Consider and approve Change Order No. 4 for KBR - Cedar Breaks Road.

CHANGE ORDER NUMBER: 4

Project: 02WC422
 Roadway: Cedar Breaks
 Purchase Order Number: _____

Project: 02WC422
Roadway: Cedar Breaks Road
Re: Change Order No. 4

**CEDAR BREAKS ROAD
CAVE AT STA 85+00**

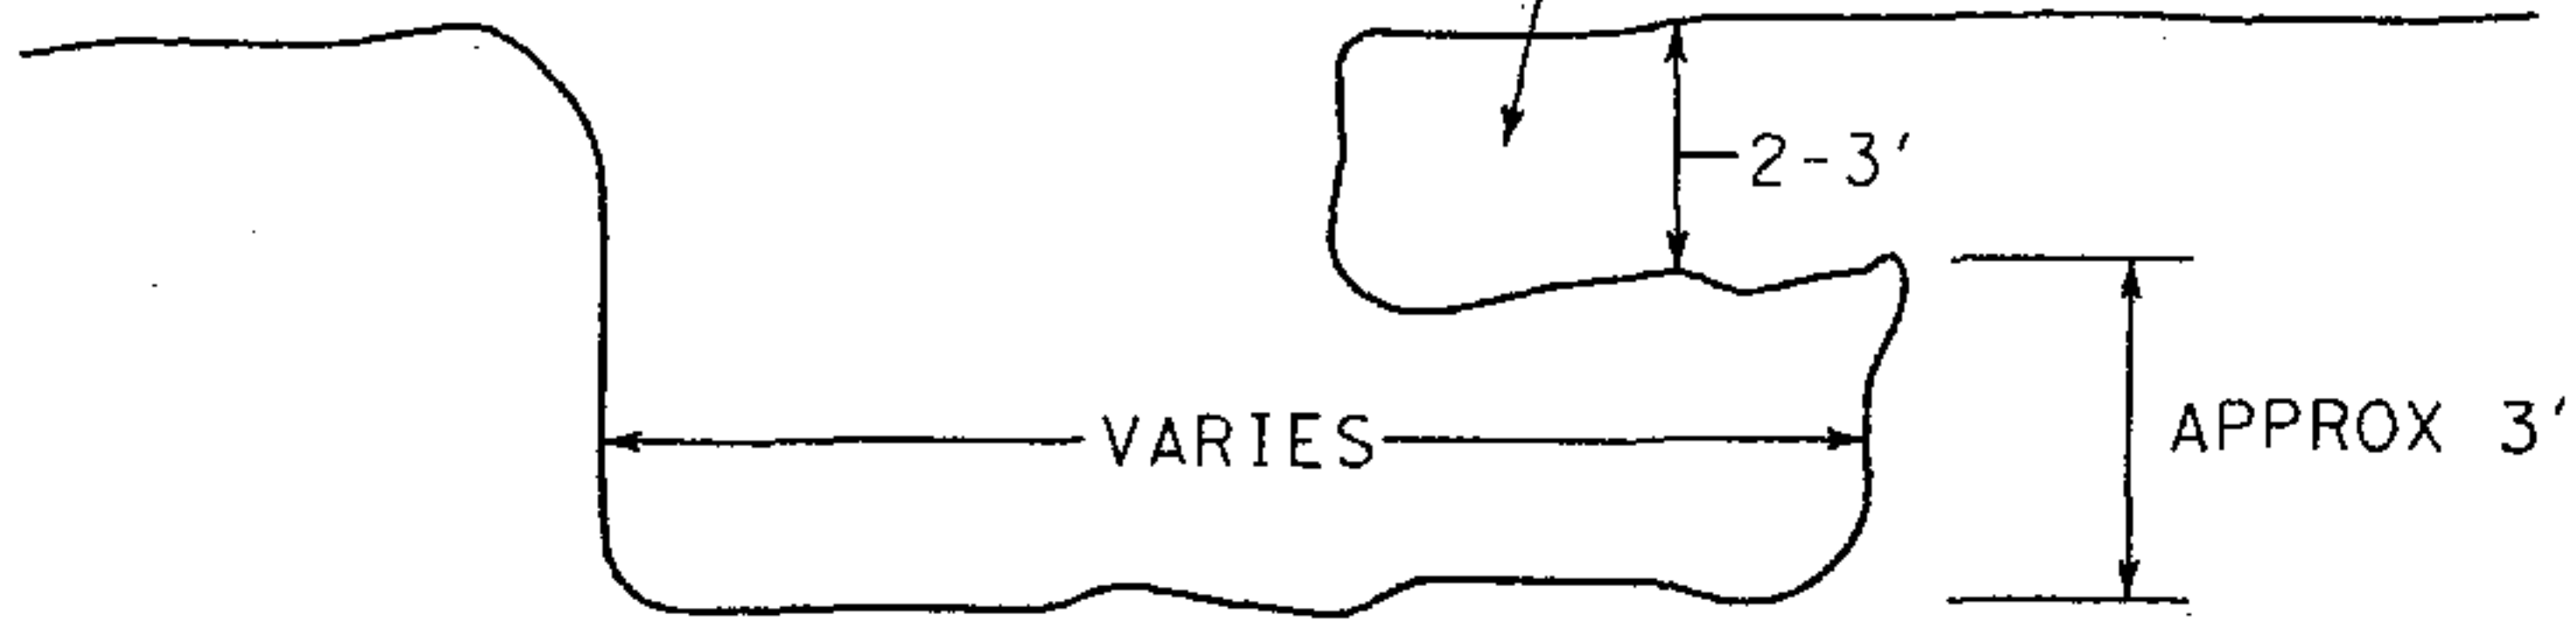
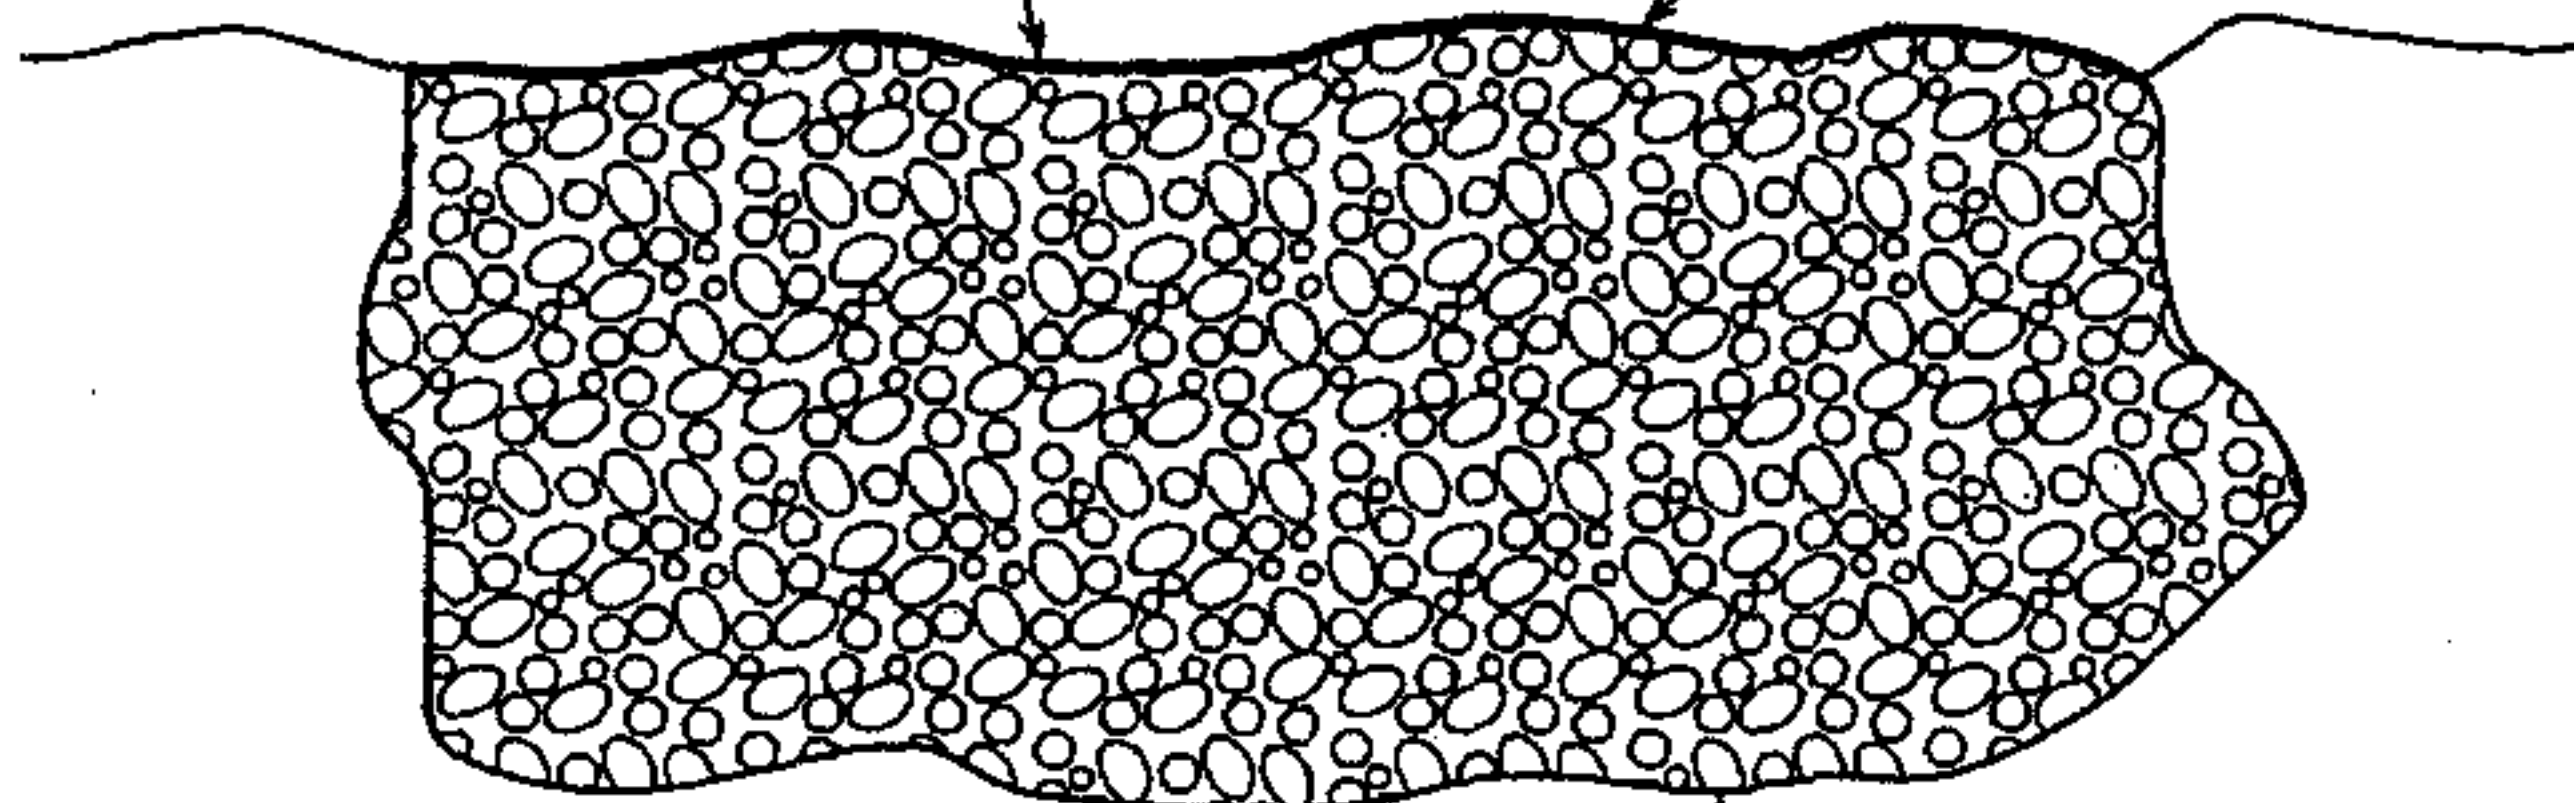
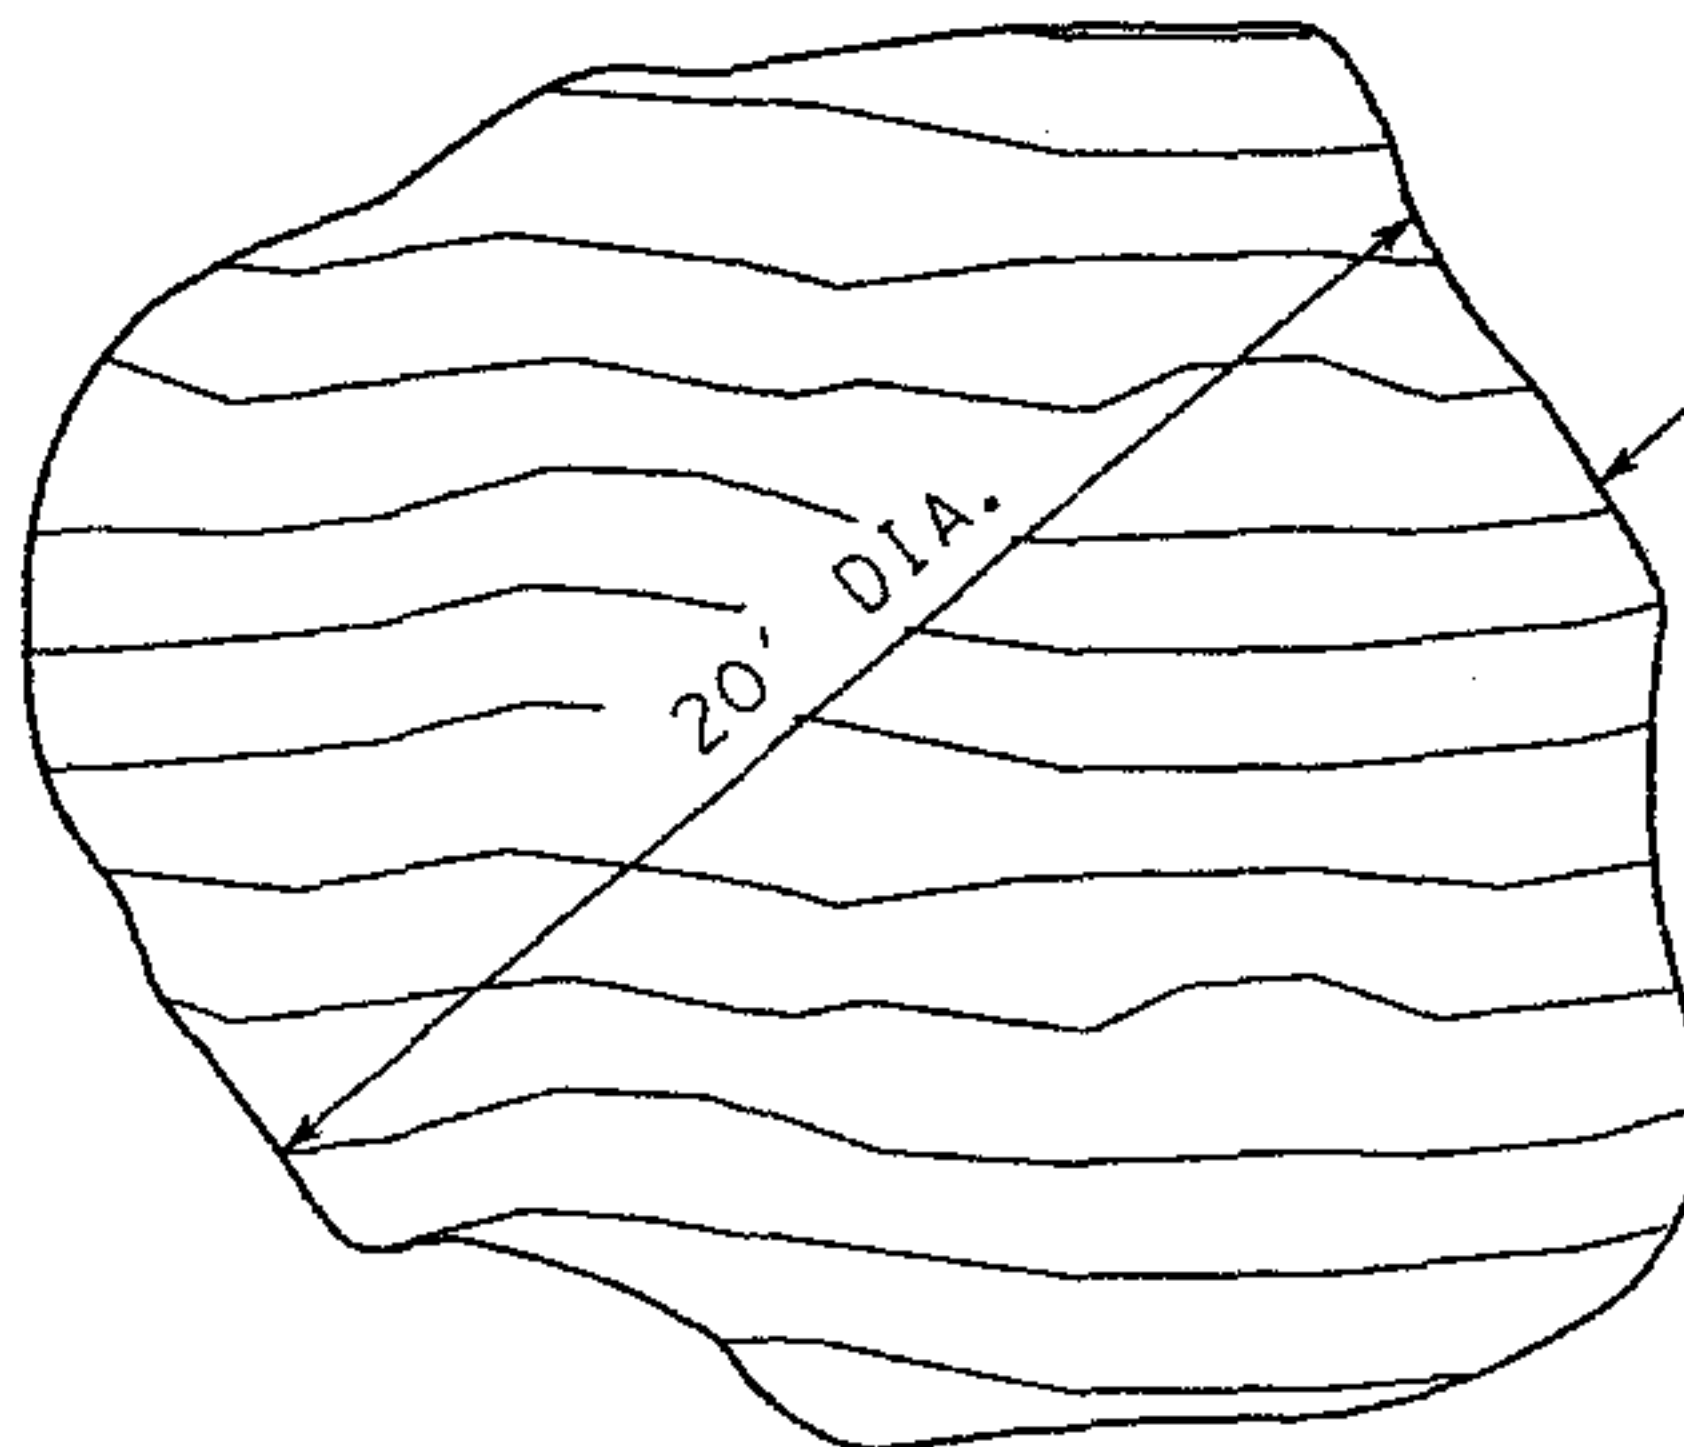
Provide compensation for changes in striping to properly accommodate the new Shell road alignment (City of Georgetown), it has been necessary to change/modify the lane configuration in the vicinity of this intersection (Sta. 155+00 to 127+38). Compensation for special excavation at sink hole as recommended on ACI consulting report item no. 2 (Sta. 85+00). Compensation for additional drive ways and drainage pipes with SET not included in original plans (sta. 20+00, 20+20 and 1086+88), and gate relocation (sta. 20+20) to adjust entrance due to change in grade of existing driveway. Compensation for the 6" HMA to allow construction of tie in points at sta. 15+50 to 18+65 and sta. 1072+50 to Sta. 1074+20. Removal of concrete driveways and construction of concrete driveways.

EXCAVATE TOTAL AREA OF CAVITY
(APPROXIMATELY 20' DIAMETER, 5' DEEP)

FILL TO PROPOSED
SURFACE GRADE AND
REVEGETATE

BACKFILL WITH STABLE,
CLEAN, WELL-SORTED
PROPERLY COMPACTED
FILL MATERIAL
